*City of El Paso – City Plan Commission Staff Report*

**Case No:** SUSU14-00034 Painted Sky at Mission Ridge  
**Application Type:** Major Combination  
**CPC Hearing Date:** May 8, 2014  
**Staff Planner:** Alejandro Palma, (915) 212-1607, [palmaaj@elpasotexas.gov](mailto:palmaaj@elpasotexas.gov)  
**Location:** North of Eastlake Boulevard and East of Joe Battle Boulevard  
**Acreage:** 92.125 Acres  
**Rep District:** ETJ  
**Existing Use:** Vacant  
**Existing Zoning:** N/A  
**Proposed Zoning:** N/A  
**Nearest Park:** Ranchos Del Sol Park (2.4 miles)  
**Nearest School:** Eastlake High School (.48 miles)  
**Park Fees Required:** N/A  
**Impact Fee Area:** N/A  
**Property Owner:** Hunt Mission Ridge, LLC.  
**Applicant:** CSA  
**Representative:** CSA

ATTACHMENT 4

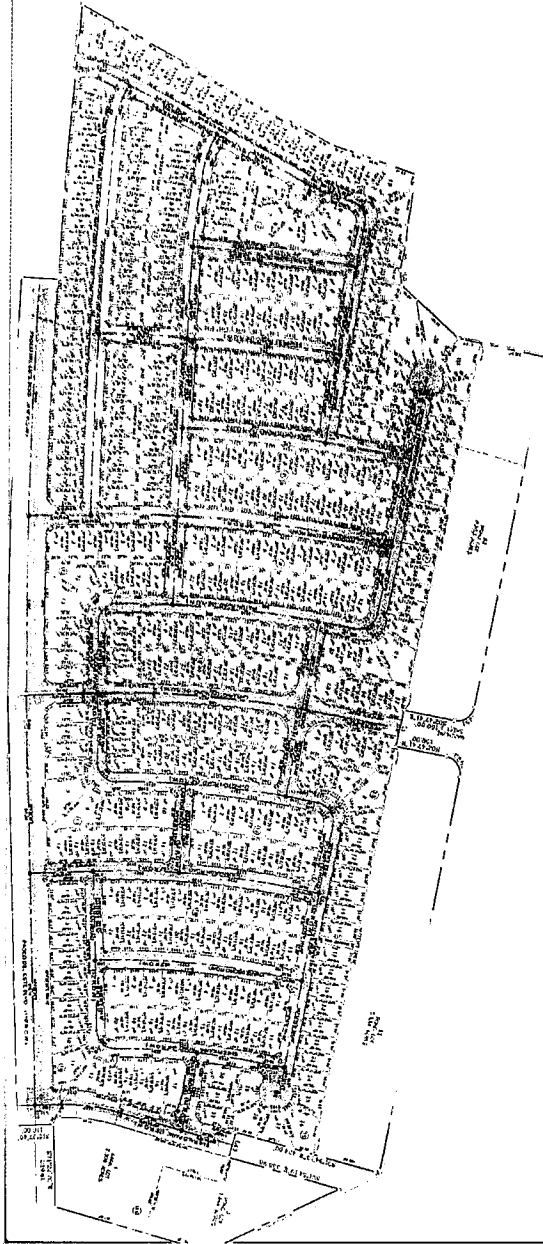
1. Verify years shown on all approval statements.
2. Incorrect CPC approval statement is shown on final plat. Please revise.
3. Illustrate location of all easements.

1. Show maintenance access road location for each proposed pond.
2. Verify adjacent subdivisions and label with the latest approved developments.
3. All downstream storm-water management facilities should be in place prior to or concurrently with the development of the subject subdivision (Title 19.01.010).
4. A portion of pond at the N.E. Lot 2 is shown extending beyond subdivision boundary limits.
5. Verify that proposed drainage infrastructure is in line with the latest City approved subdivision improvement plans.
